RE: Informal Data Response, Set 6A  
San Francisco Electric Reliability Project (04-AFC-1)

**SAN FRANCISCO ELECTRIC  
RELIABILITY PROJECT  
(04-AFC-1)**

**INFORMAL DATA RESPONSE,  
SET 6A**

**FIGURE S&W6-8**  
**SAN FRANCISCO ELECTRICAL**  
**RELIABILITY PROJECT**  
 APPLICATION FOR CERTIFICATION

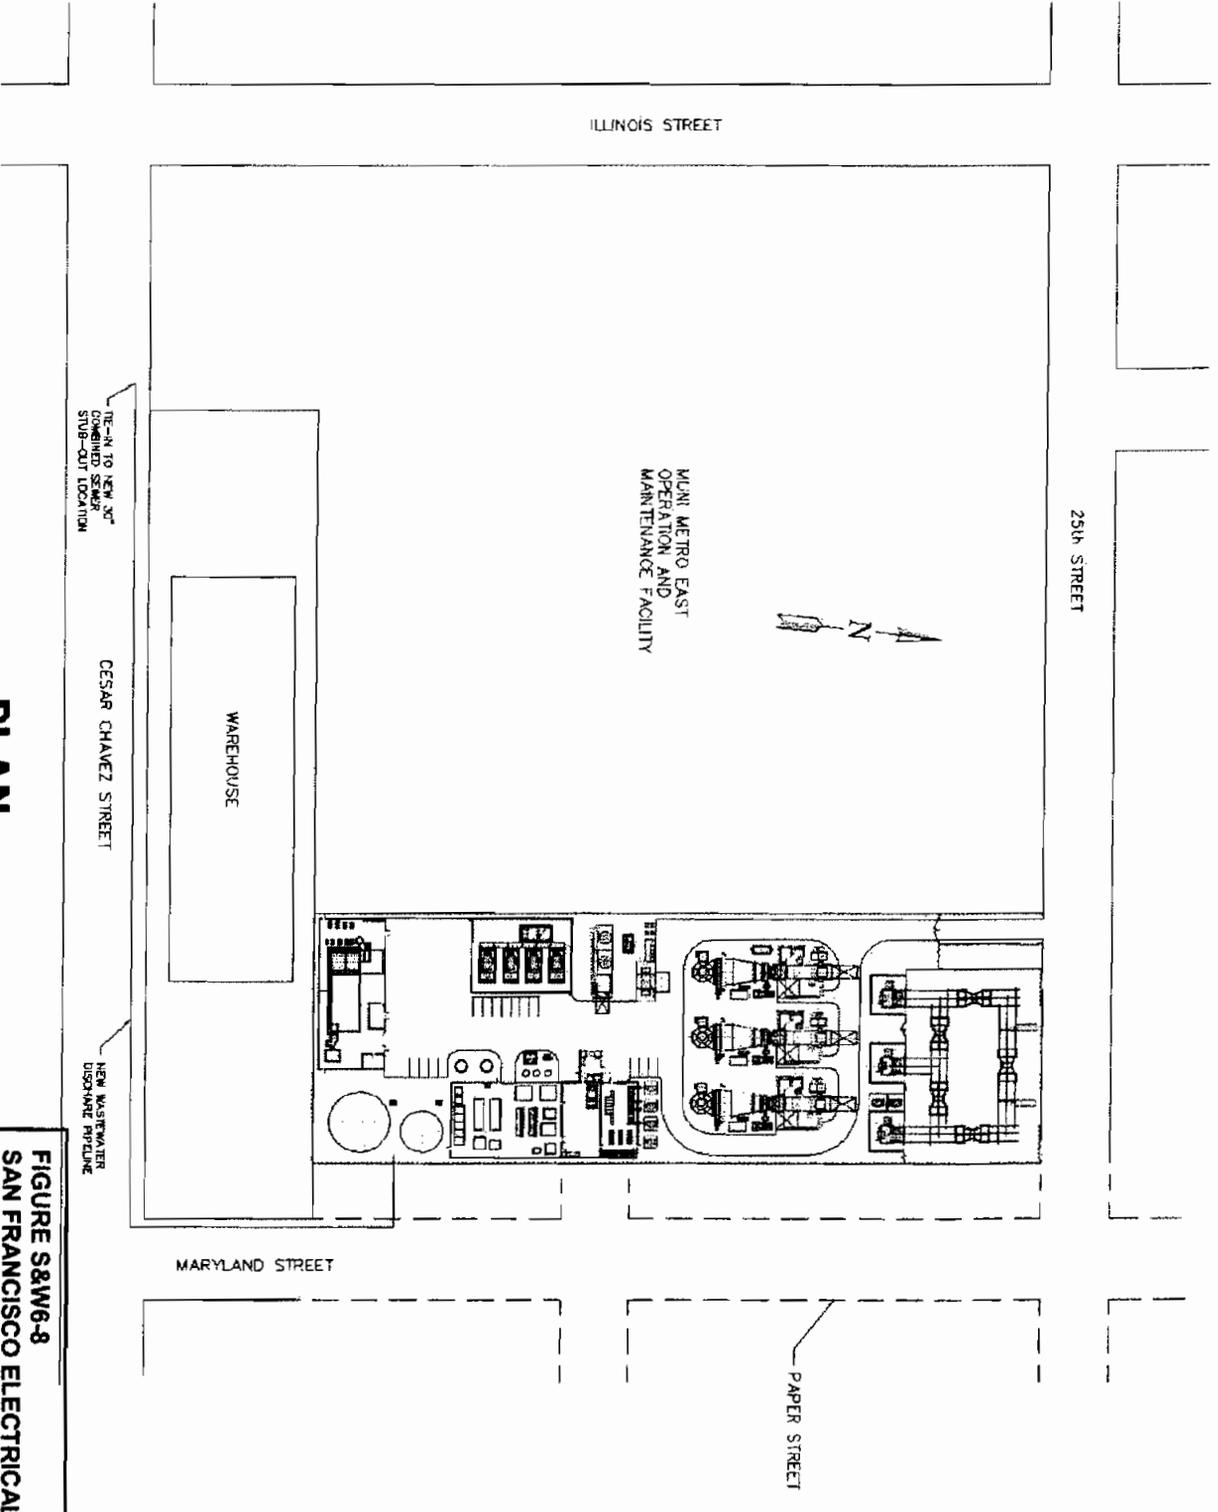
S&W6-8. Provide a site map that shows the location of the wastewater discharge pipeline from the SFERP site wastewater sump to the terminus connection with the existing City sewer line.

**Response:** Please see attached Figure S&W6-8.
